RESPONSES TO COMMENTS

UNITED STATES NUCLEAR REGULATORY COMMISSION COMMENTS REGARDING THE DRAFT FINAL SAMPLING AND ANALYSIS PLANS FOR THE REMEDIAL INVESTIGATIONS AT SPRING CREEK PARK AND DEAD HORSE BAY SITES GATEWAY NATIONAL RECREATION AREA, NEW YORK

Final

December 4, 2024

Maps Showing Gamma Survey Areas at Spring Creek Park and Dead Horse Bay

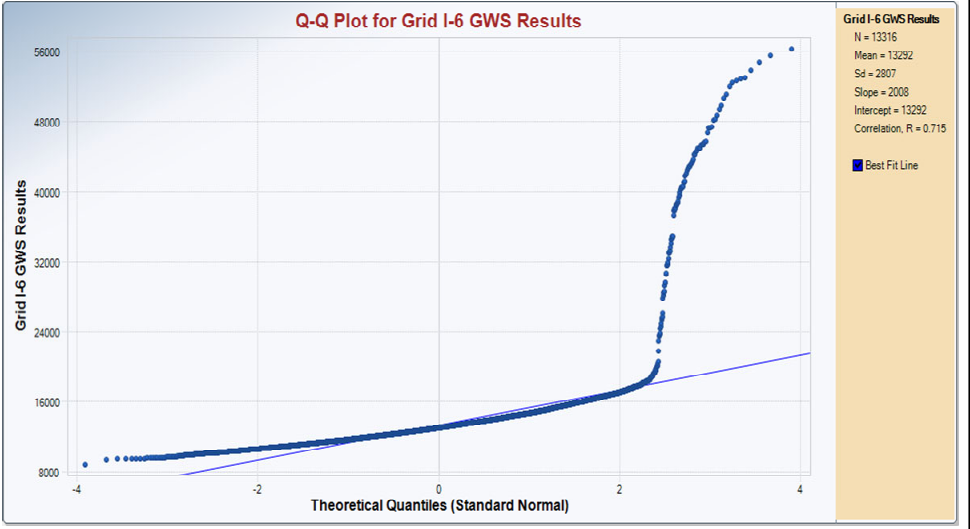
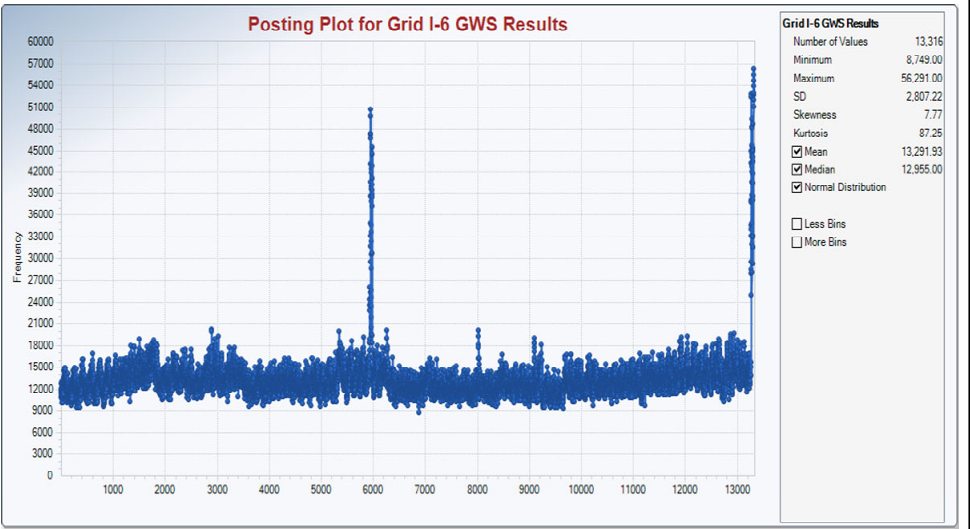
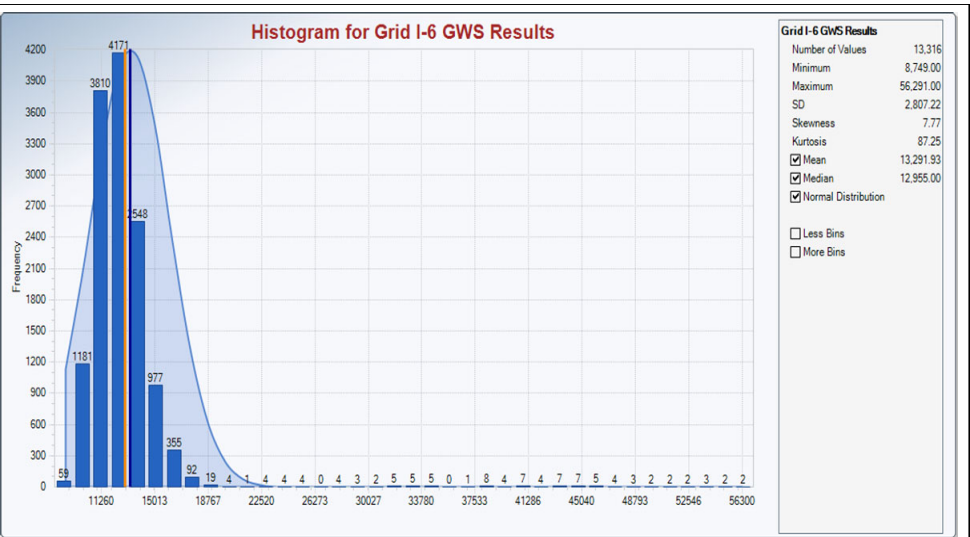
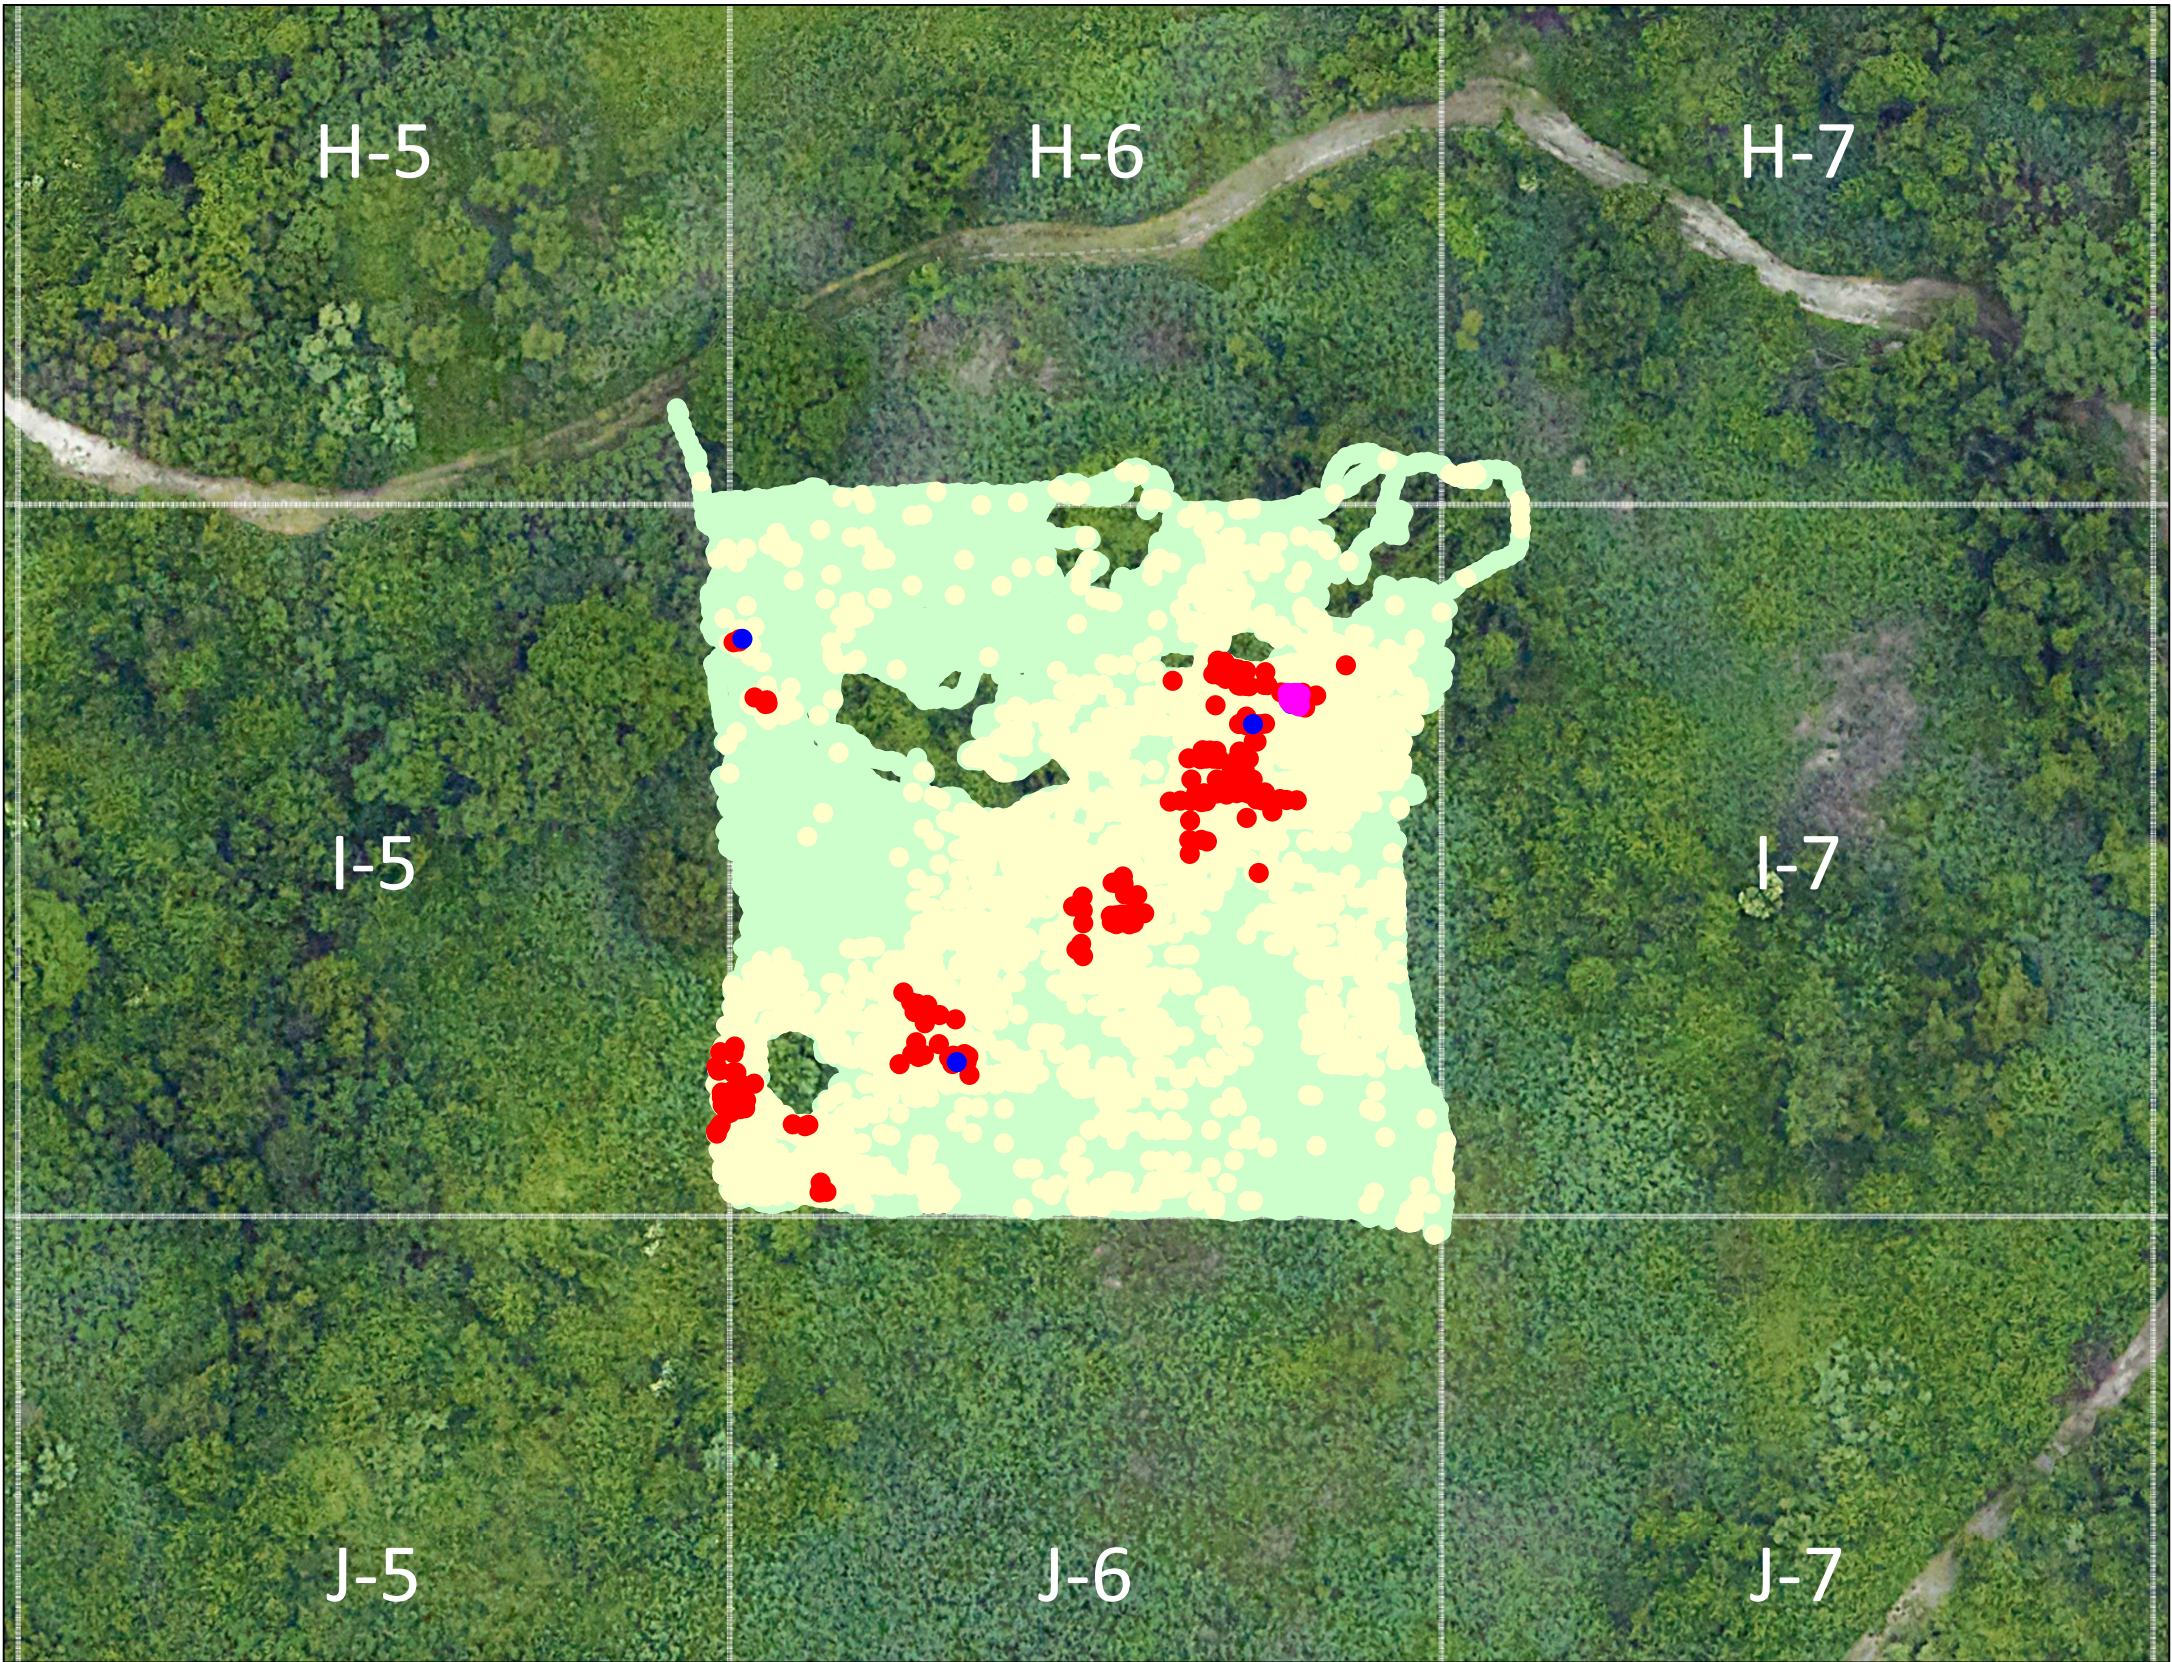
Comment 1: Limited Gamma Walkover Survey Coverage: The NRC staff recommends that the NPS provide a discussion of decision-making procedures for determining gamma walkover survey (GWS) coverage and estimating the potential distribution of radiological contamination at the site.

Description: In Section 2.2 of both the SCP and DHB SAPs, NPS details previous GWSs with limited coverage of each site. For example, the SCP SAP (page 34) describes surveys along fire roads plus a 10-foot buffer on each side of the road—Figure 2-12 presents the results. It is noted that some areas received additional coverage, specifically the southeastern sector, though most of the property remains unscanned. Overall, based on visual inspection by NRC’s contractor, survey results appear to represent 5- to 10-percent coverage. Figure 2-12 of the SCP SAP also illustrates locations where discreet sources of radium were identified, including three deck markers and one radium clip.

Similarly, in the DHB SAP, the NPS describes a GWS for various areas including trails and beaches initially, then alternating 1-acre grids in the southern portion of the site, and additional coverage in the vicinity of the marina (see Figure 2-11). Based on visual inspection by NRC’s contractor, survey results appear to represent approximately 30- to 40-percent coverage on the southern portion and 5- to 10-percent in the northern portion. Section 2.2.2 of the DHB SAP details the identification of two radium deck markers in the initial GWS of trails and beaches in the southern portion of the site. Section 2.2.4 of the DHB SAP indicates that several elevated anomalies were identified but not investigated further, and further radiological investigations will be performed as part of the current phase of the remedial investigation to better characterize radiological sources and the nature and extent of radiological contamination at the site.

It is not known if the distributions of identified radiological artifacts is representative of the site as a whole or if larger concentrations of sources are in areas of both sites that were not scanned.

Assuming 10-percent coverage was achieved at SCP, one can conclude, based on pure randomness, that a total of 40 discrete sources could be distributed across the property. In Section 5.5 of the SCP SAP, NPS describes GWSs with limited coverage goals that essentially rescan previous areas to address data quality issues identified in Section 2.2.7 of the SCP SAP. While NPS does not propose GWS for this phase of the remedial investigation at DHB, similar uncertainty exists given the currently available data from previous investigations.

NPS Response: The approach to radiological investigations for Spring Creek Park (SCP) and Dead Horse Bay (DHB) is to confirm that the conceptual site model (CSM) that was established at Great Kills Park (GKP) is the same at these two sites. GKP was the first of the three Gateway Sites to be investigated for radiological contamination (i.e., in addition to a broad list of chemical contaminants). The radiological investigation at GKP involved completing gamma surveys over 100% of the waste filled area. The investigation confirmed that discrete artifacts and distributed radiological contamination, primarily radium-226 and to a lesser extent thorium-232 and uranium-238, is associated with waste fill. The radiological investigations for SCP and DHB were initiated due to their similar history (i.e., both created through historical landfilling operations performed by New York City). The reduced GWS coverage is appropriate for SCP and DHB because radiological contamination has already been discovered in waste filled areas at both sites, both sites have the same operational history as GKP, and 50% GWS coverage combined with our focused radiological investigation approach will generate sufficient site data to confirm that the CSMs at both sites are the same as GKP (i.e., radiological contamination is associated with waste fill, and wherever waste fill is present, there is a likelihood of encountering radiological contamination). NPS's current plan is to determine the waste fill extents and complete gamma surveys over roughly 50% of SCP and DHB so that there are sufficient radiological anomalies within the surveyed area to support focused radiological investigations to characterize the nature of radiological contamination (including radiological sources in waste fill) and to inform the human health risk assessment and radiological dose assessment.

The gamma surveys are being conducted to support worker health and safety and site management decisions and, as a result, these tasks were not specifically included in the fieldwork specified in the RI SAPs. However, the gamma surveys are considered usable for characterizing radiological contamination that can be detected at the ground surface and will be used in the RI to support the selection of areas for focused radiological investigations at both sites. The maps presented in **Attachment 1** provide a summary of the gamma surveys that have been conducted and/or are planned at DHB and SCP. In addition to the gamma surveys shown in **Attachment 1**, gamma surveys will also be performed in the northern portion of DHB (i.e., targeting approximately 50% coverage) once the extent of waste fill is defined through the activities described in the Phase 1 RI SAP for DHB.

Both SCP and DHB were created through historical landfilling operations conducted by New York City and radiological contamination has already been discovered at both sites during limited investigations around paths and accessible areas. NPS is confident that 50% GWS survey coverage along with waste fill delineations will provide sufficient radiological anomalies to further characterize the radiological impacts associated with waste fill at both sites. Also, NPS anticipates that CERCLA response actions will be required to protect human health, achieve federal and state dose limits, and protect the environment prior to reopening any of these sites to the public (i.e., these sites are not being considered for unrestricted release in their current condition). Impacted areas of GKP, SCP, and DHB will remain closed while NPS sequences through the CERCLA process.
